Access Compliance Report

Public Rights-of-Way

Intersection ID: 45789	Main Street: WINDING_RIVER_DR	Cross Street: GARMAN_HILL_DR	Location: SW
ADA ID: 015AF6DBA39B	Ramp Type: BlendTrans1	Initial Pass/Fail: Fail	Overall Compliance: No
			Severity Score: 33.75

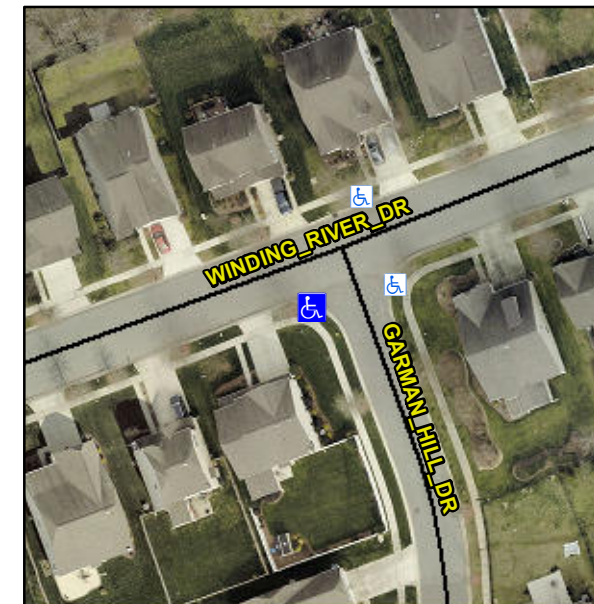
R304.5.1, R304.5.3

Compliance	Description	Data	Compliance	Description	Data
N/A	Ramp Length (in)	70.0	Yes	BlendTrans Slope (%)	4.0
No	Ramp Width (in)	44.0	No	BlendTrans XSlope (%)	9.5
N/A	Flare Type LT	N/A	N/A	Flare Type RT	N/A
N/A	Flare Slope LT (%)	N/A	N/A	Flare Slope RT (%)	N/A
N/A	Flare Traversable LT?	N/A	N/A	Flare Traversable RT?	N/A
N/A	Landing Length (in)	N/A	N/A	DWS Provided?	N/A
N/A	Landing Width (in)	N/A	N/A	DWS Contrast?	N/A
N/A	Landing Slope (%)	N/A	N/A	DWS Length (in)	N/A
N/A	Landing X Slope (%)	N/A	N/A	DWS Full Width?	N/A
N/A	Landing Curb? (Y/N)	N/A	N/A	DWS Offset (in)	N/A
N/A	Shared Landing?	N/A			
N/A	Gutter Ponding?	N/A	N/A	Gutter Slope (%)	N/A
N/A	Gutter Lip Ht (in)	N/A	N/A	Gutter X Slope (%)	N/A
N/A	Painted X Walk1?	No	N/A	Painted X Walk2?	No
	X Walk 1 Direction	To E		X Walk 2 Direction	To N
	X Walk 1 Width (in)	N/A		X Walk 2 Width (in)	N/A
	X Walk 1 Slope (%)	5.3		X Walk 2 Slope (%)	1.5
	X Walk 1 X Slope (%)	4.1		X Walk 2 X Slope (%)	5.7

Remove & Replace Curb Ramp With Two New Directional Ramps or Equivalent.
